145.2.5.6 Functions: Add option_class_probe_only.

145.2.5.6 Functions: Add pri and sec versions of do_class_probe.

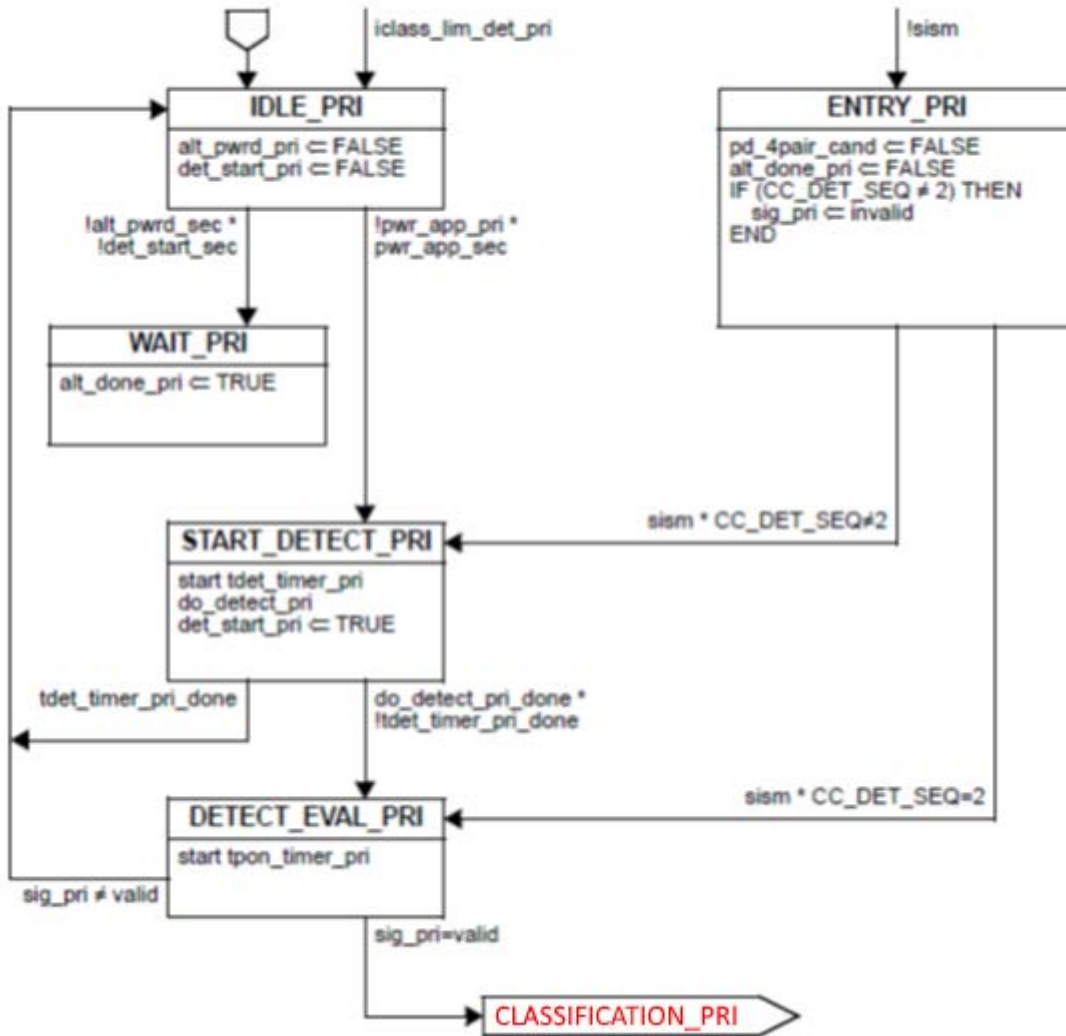
Modify Figure 145-13 to allow return to IDLE after CLASS_PROBE

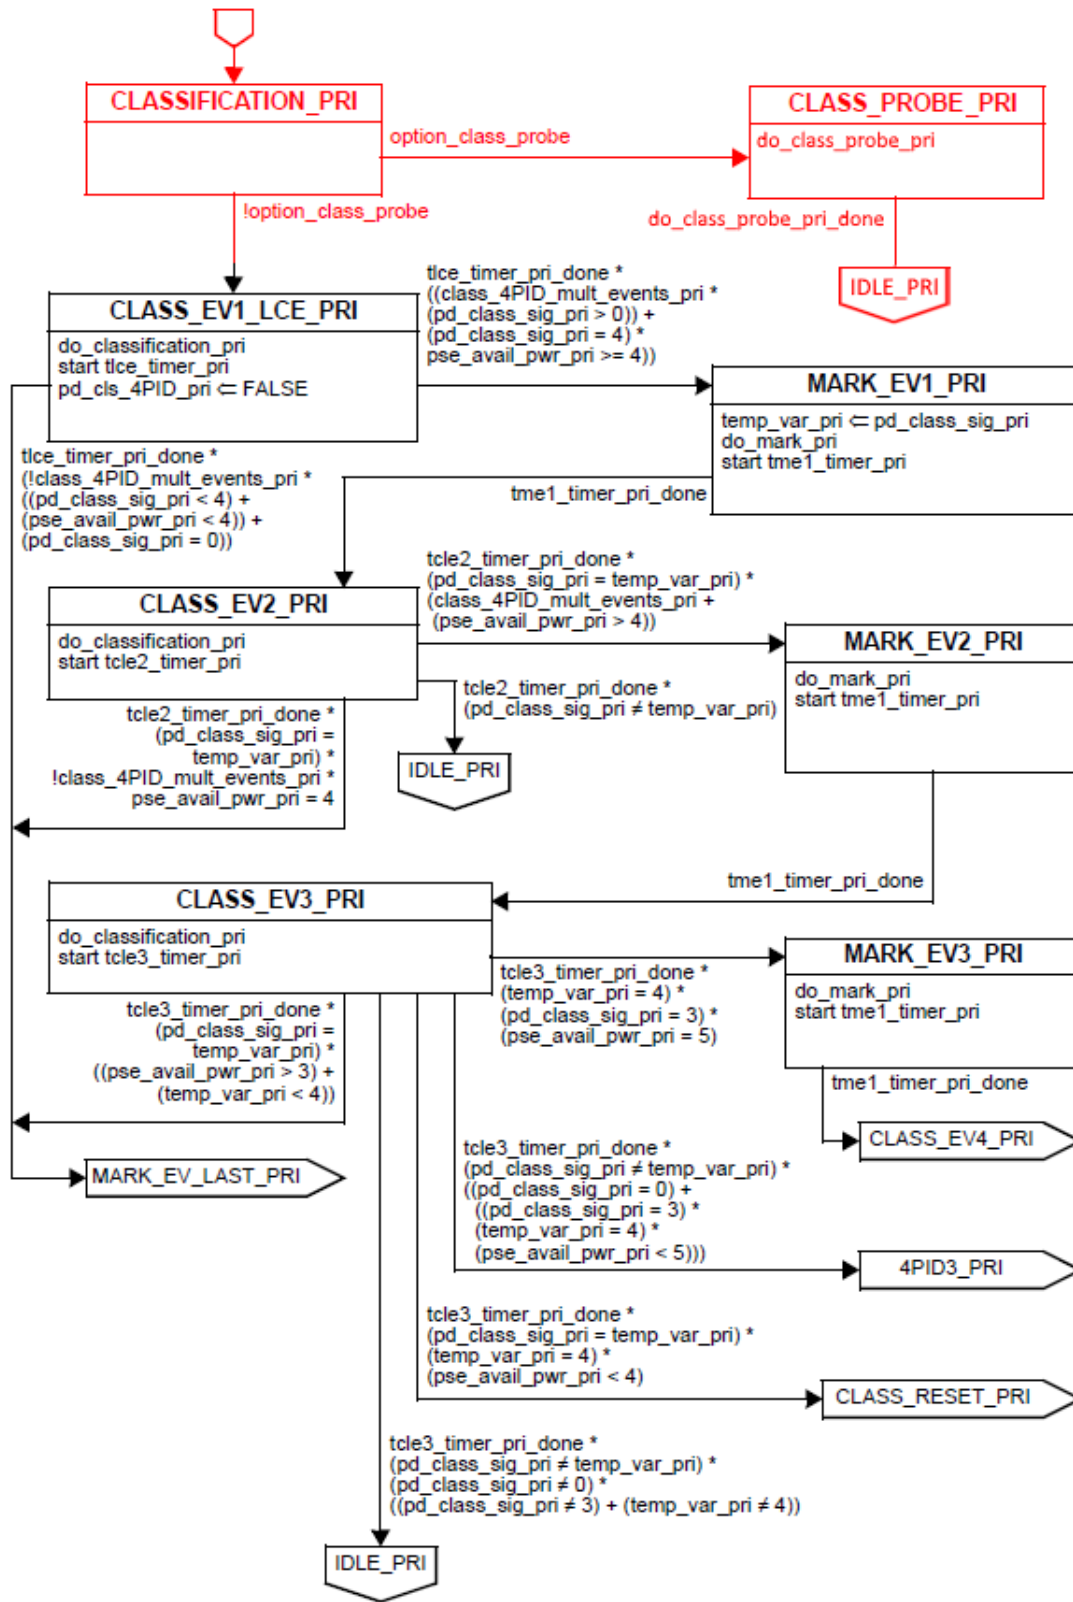
Modify Figure 145-15 to allow return to IDLE_PRI after CLASS_PROBE_PRI

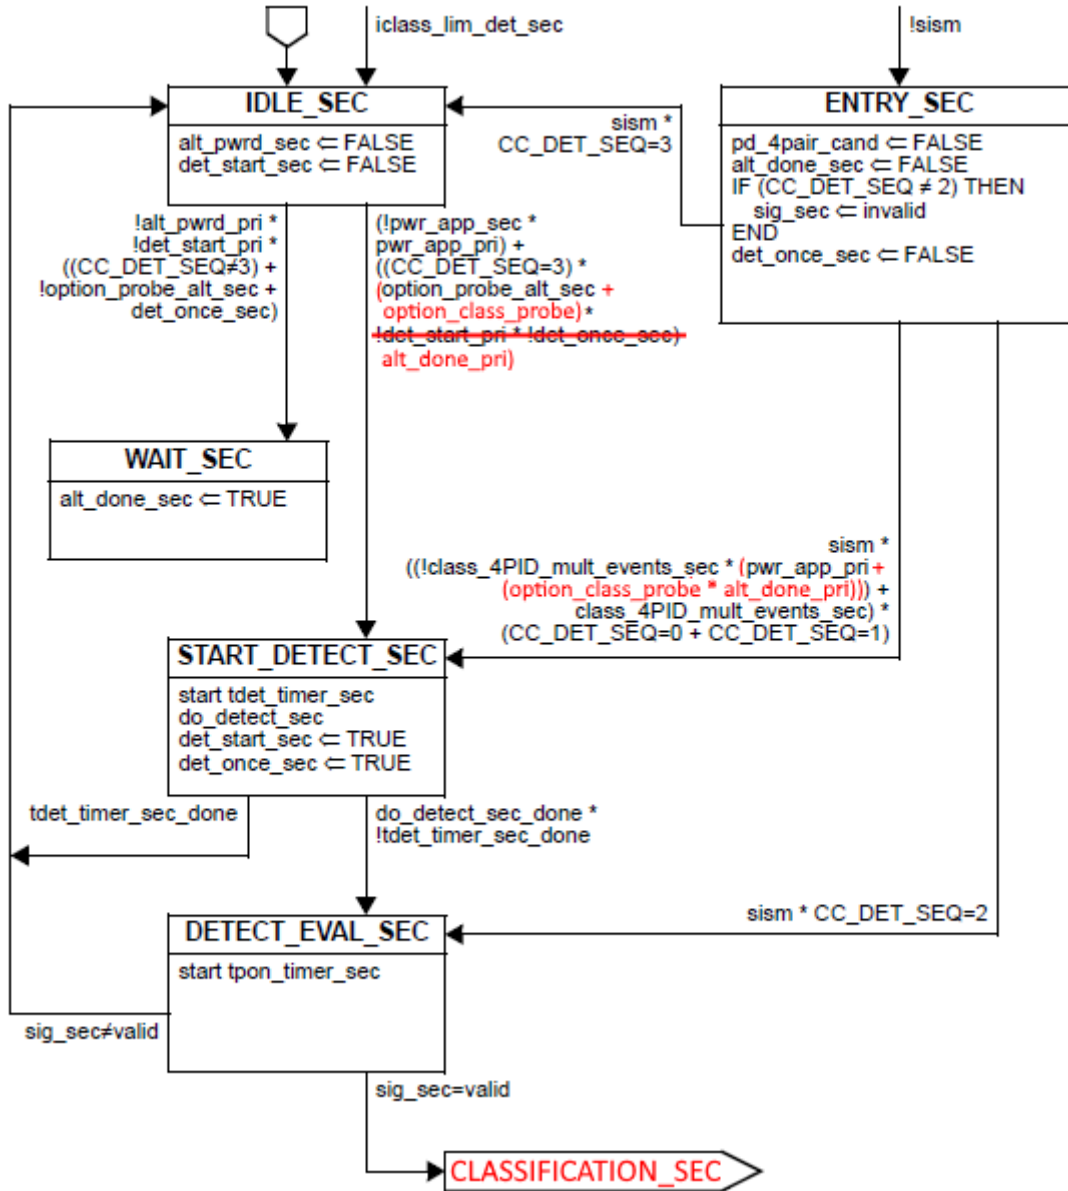
Modify Figure 145-15 to allow CLASS_PROBE_PRI
